Access Compliance Report

Public Rights-of-Way

(Curb Ramps)

Intersection ID: 24485	Main Street: CAMAROSS_DR	Cross Street: SAINTFIELD_PL	Location: NE
ADA ID: BACF8261F1BD	Ramp Type: Perp	Initial Pass/Fail: Fail	Overall Compliance: No
Severity Score: 22.5			
Codes/Mitigation Info/Possible Solution		Field Measurements/Component Compliance

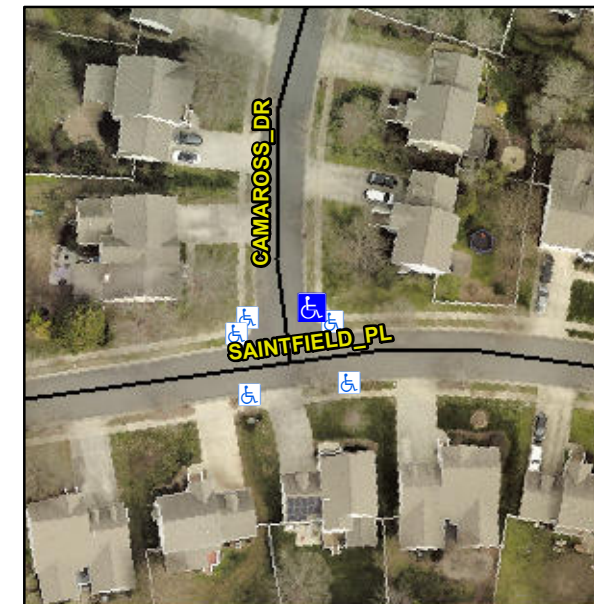
R304.5.1, R304.2.2, R304.5.3

Compliance	Description	Data	Compliance	Description	Data
N/A	Ramp Length (in)	46.0	No	Ramp Slope (%)	8.9
No	Ramp Width (in)	39.0	No	Ramp XSlope (%)	4.0
N/A	Flare Type LT	N/A	N/A	Flare Type RT	N/A
N/A	Flare Slope LT (%)	N/A	N/A	Flare Slope RT (%)	N/A
N/A	Flare Traversable LT?	N/A	N/A	Flare Traversable RT?	N/A
N/A	Landing Length (in)	N/A	N/A	DWS Provided?	N/A
N/A	Landing Width (in)	N/A	N/A	DWS Contrast?	N/A
N/A	Landing Slope (%)	N/A	N/A	DWS Length (in)	N/A
N/A	Landing X Slope (%)	N/A	N/A	DWS Full Width?	N/A
N/A	Landing Curb? (Y/N)	N/A	N/A	DWS Offset (in)	N/A
N/A	Shared Landing?	N/A			
N/A	Gutter Ponding?	N/A	N/A	Gutter Slope (%)	N/A
N/A	Gutter Lip Ht (in)	N/A	N/A	Gutter X Slope (%)	N/A
N/A	Painted X Walk1?	No	N/A	Painted X Walk2?	N/A
	X Walk 1 Direction	To W		X Walk 2 Direction	N/A
N/A	X Walk 1 Width (in)	N/A	N/A	X Walk 2 Width (in)	N/A
	X Walk 1 Slope (%)	0.8		X Walk 2 Slope (%)	N/A
	X Walk 1 X Slope (%)	2.2		X Walk 2 X Slope (%)	N/A

Remove & Replace Entire Ramp.
